Informal document **GRVA-11-35**
11th GRVA, 27 Sept.-1 Oct. 2021
Agenda item 9(b)

Proposal for a revision of UN Regulation No. 90

1. Brake Disc Grouping Criteria for L-cat vehicles

Lightening mounting bell

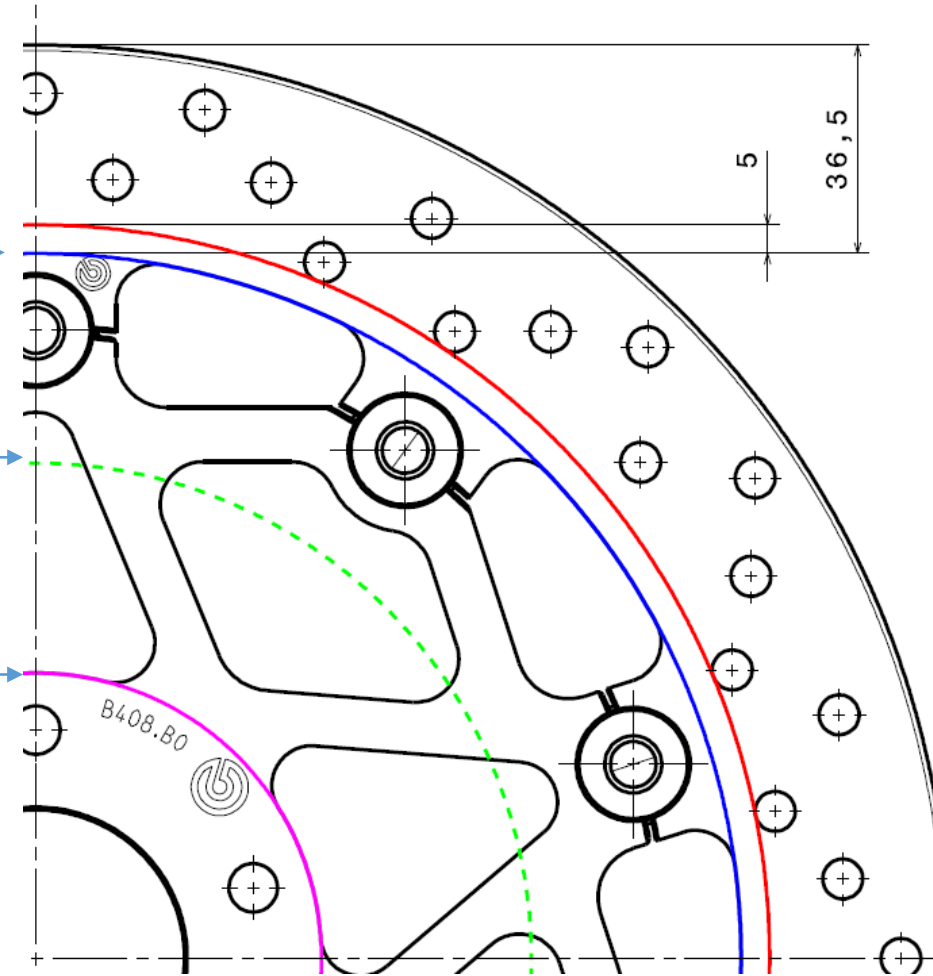
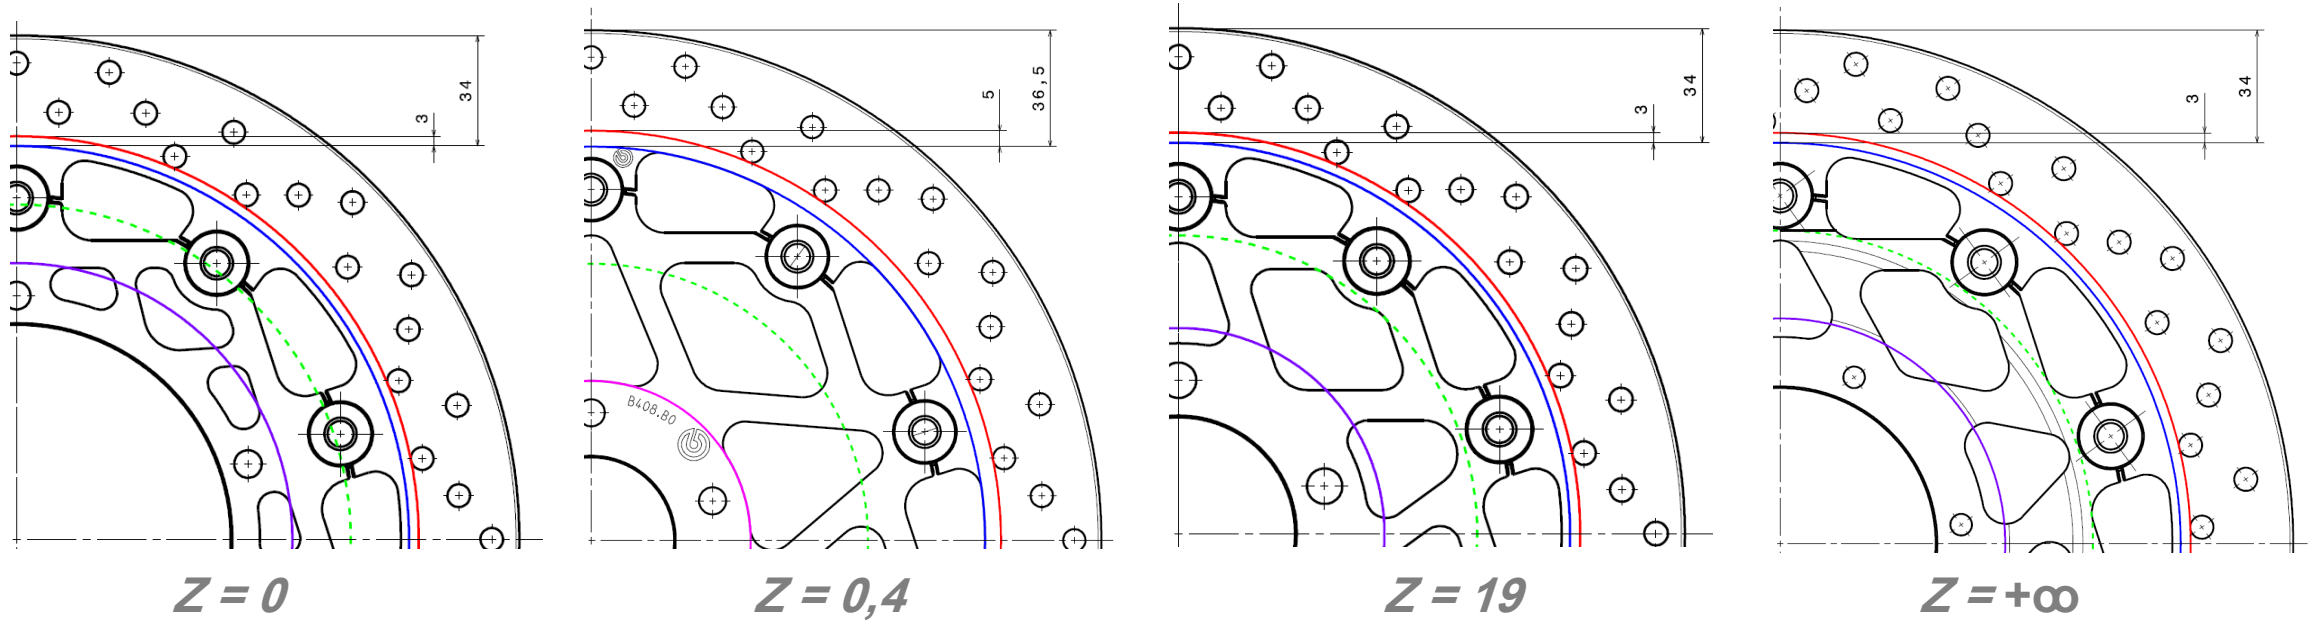
§ 2.6 Spokes of the bell with full/empty ratio –
measured on the average circumference between end
of the mounting face and beginning of the braking
surface

Calculation made on disc with similar bell shape gives very different results:

CASE1: The average circumference is external to the bell $Z=0$

CASE 2/3: Discs with similar shape have different ratio $Z=0,4$ Vs 19

CASE 4: The average circumference is external to bell spokes $Z=\infty$

Lightening mounting bell

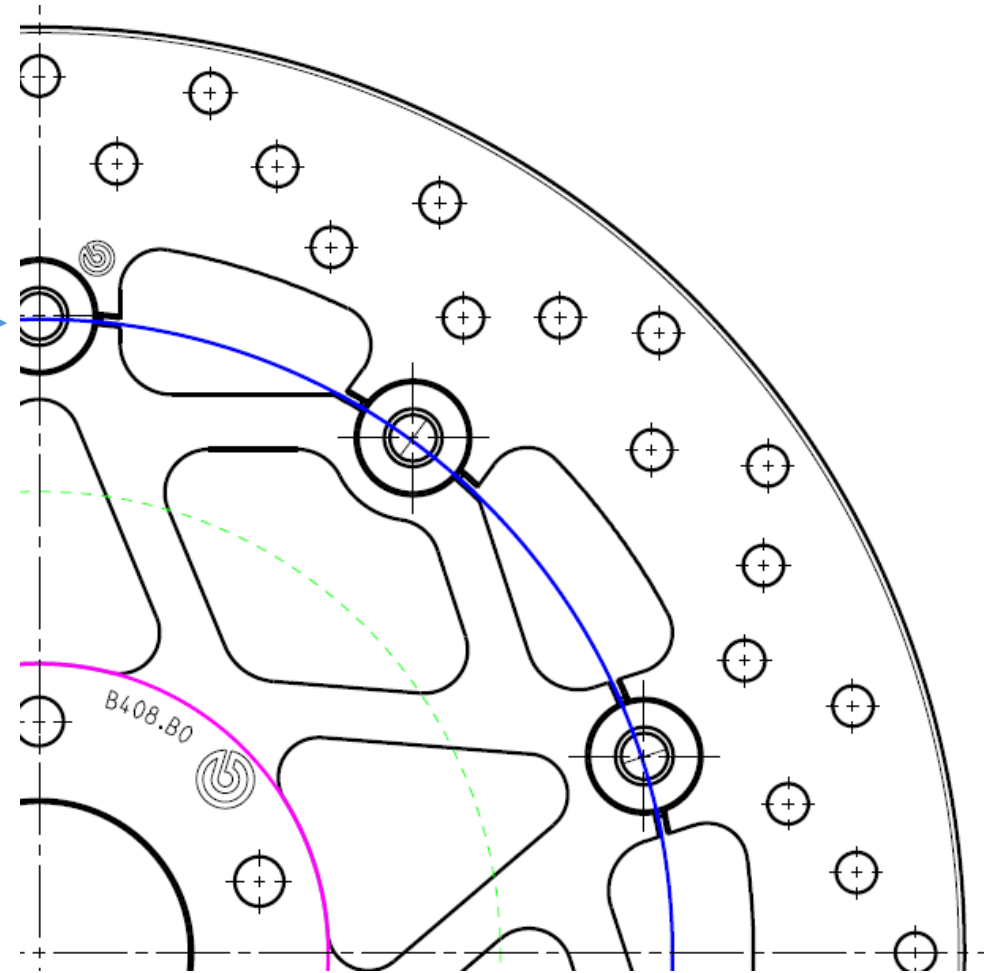
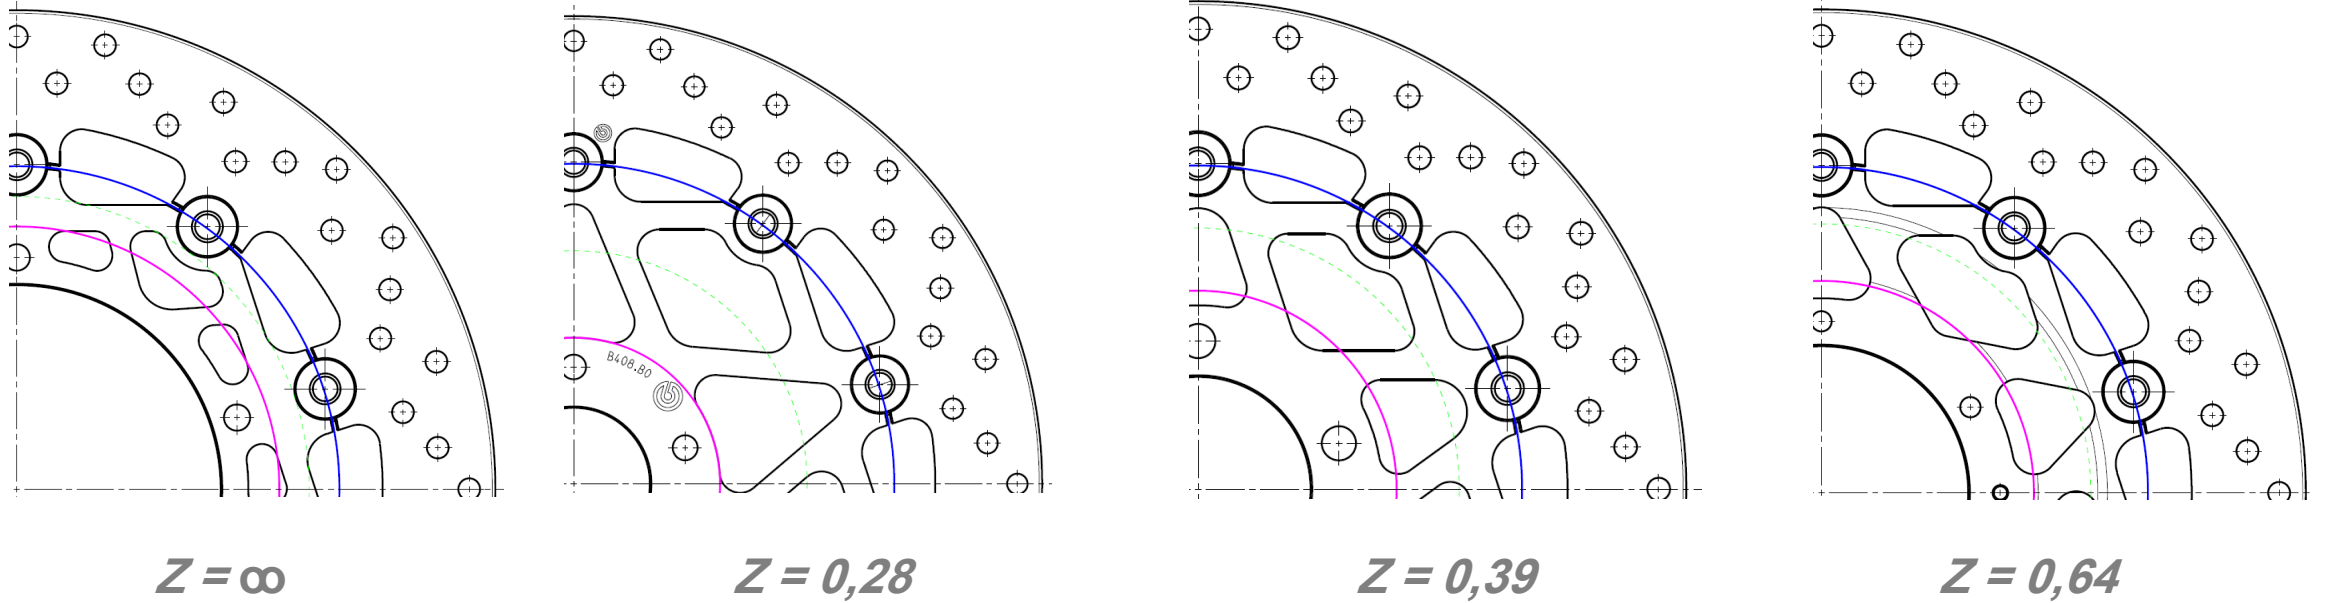
§ 2.6 **Spokes of the bell** with full/empty ratio –
measured on the average circumference between end
of the mounting face and ~~beginning of the braking~~
~~surface~~ the maximum diameter of bell

By applying the proposed modification the calculation is related only to the bell characteristics (no influence of braking surface geometry on the results) and gives a more balanced output.
